SERVICE BULLETIN # 1112

SUBJECT NEW STEEL BREAKER BOX COVER

MODEL 1-71, 1-81, 1-81 HD DATE 11/1/60

FIGURE 1

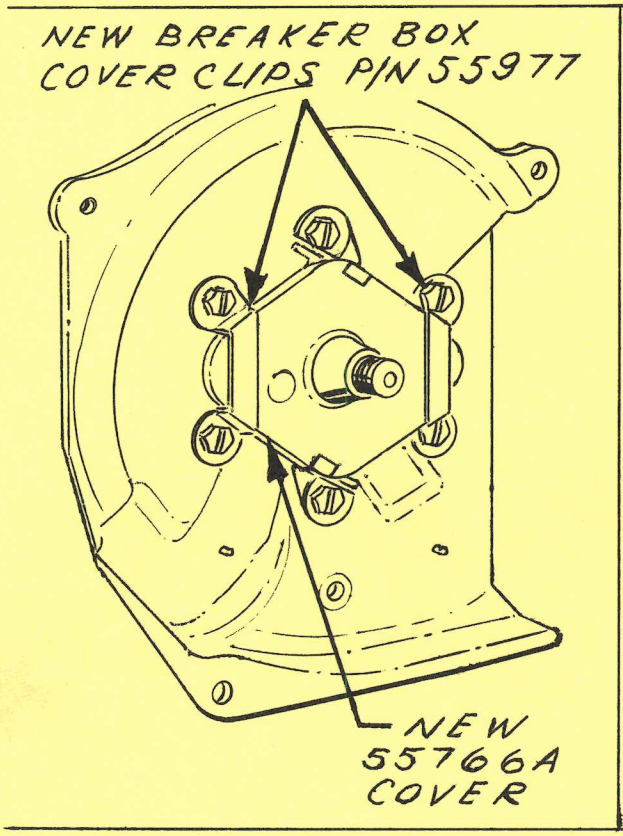
A new moisture - and dirt-proof Breaker Box Cover, P/N 55766A (shown in Figure 1 above), is available for service replacement on Model 1-71, 1-81, and 1-81 HD engines. The new steel cover replaces the earlier plastic cover, P/N 55766.

2. Put the new Breaker Box Cover over the breaker points and secure with two new Breaker Box Cover Clips, P/N 55977, and four of the original retaining screws just removed (see Figure 1).
